ENCLOSURE 1

Question: Section 4.3 and Section 4.5, General

ENCLOSURE 2

ATTACHMENT 2A

SECTIONS 29, 30, 31 AND 32
T 9 S - R 3 E
ALTERNATIVE SITE 10
AREA OF INTEREST - - - - -
SCALE: 1" = 2000'

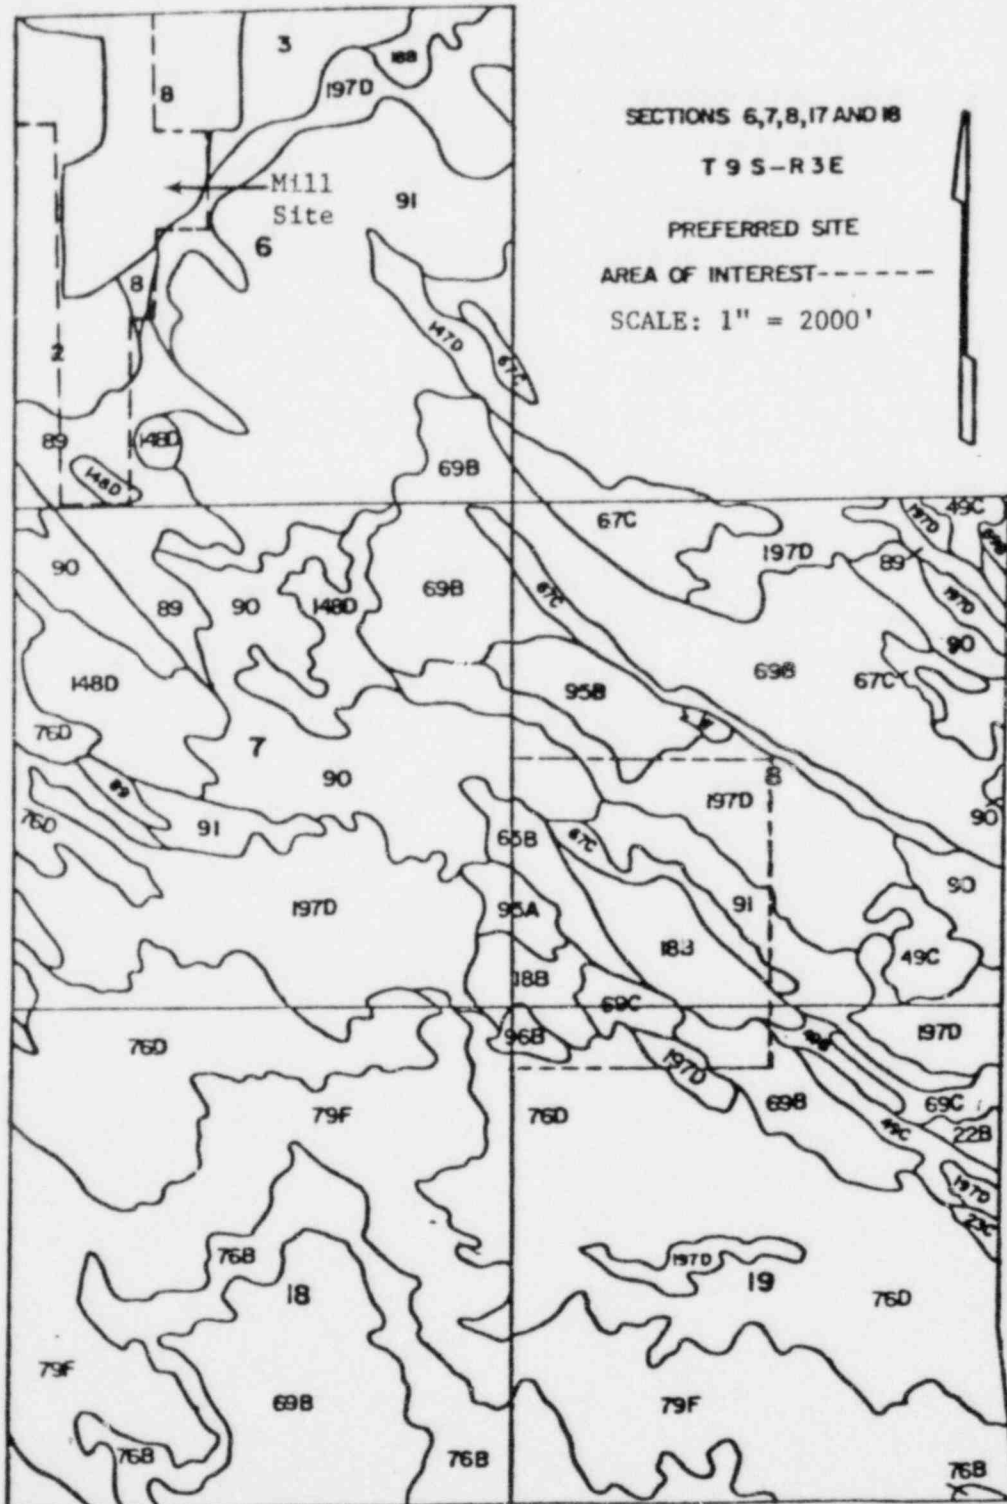
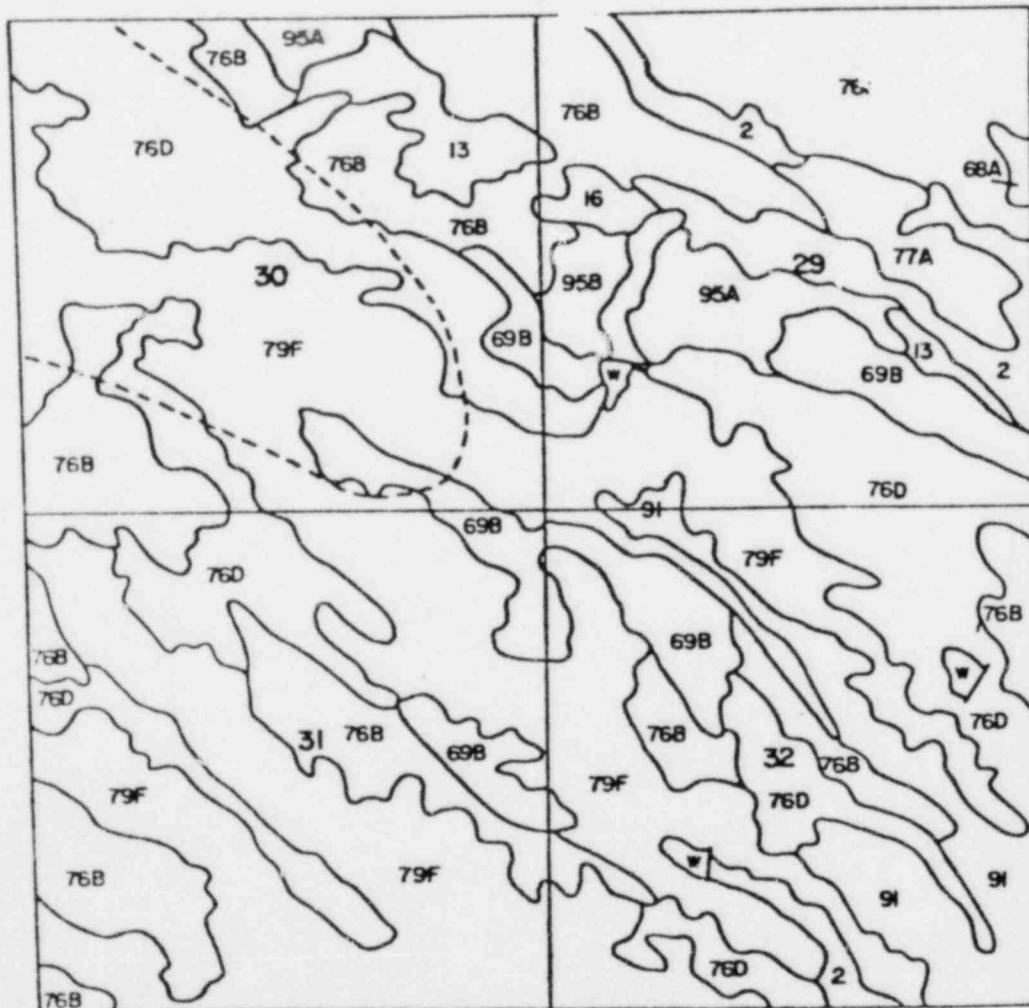
The U.S. Soil Conservation Service should review all areas likely to be disturbed for the presence of prime farmlands. Provide a letter from the state soil conservationist indicating if any prime farmland or additional land of statewide or local importance will be affected by the project.

Provide soil maps (approximately 1" = 500') indicating the location of the mill complex, proposed disposal site and alternatives, and any borrow areas for soils required for clay liner and topsoil.

Attachment 2A contains soil association maps of Alternative Sites 8 and 10 and the preferred site provided by the Soil Conservatio.. Service (SCS). Also included in Attachment 2A is a table which provides SCS cropland capability units for these maps.

Although the disposal and alternative sites may include soil units with a III rating, the small size, or discontinuous nature of the units, combined with inadequate water supplies discourages cultivation.

Soils maps are provided in Attachment 2A. Attachment 2D contains detailed site interpretations for these maps. Soils maps at a scale of 1"=500' were not available for three sites. Therefore, Site 8 is included at a scale of 1"=1000' and the preferred site and Site 10 are included at a scale of 1"=2000'.
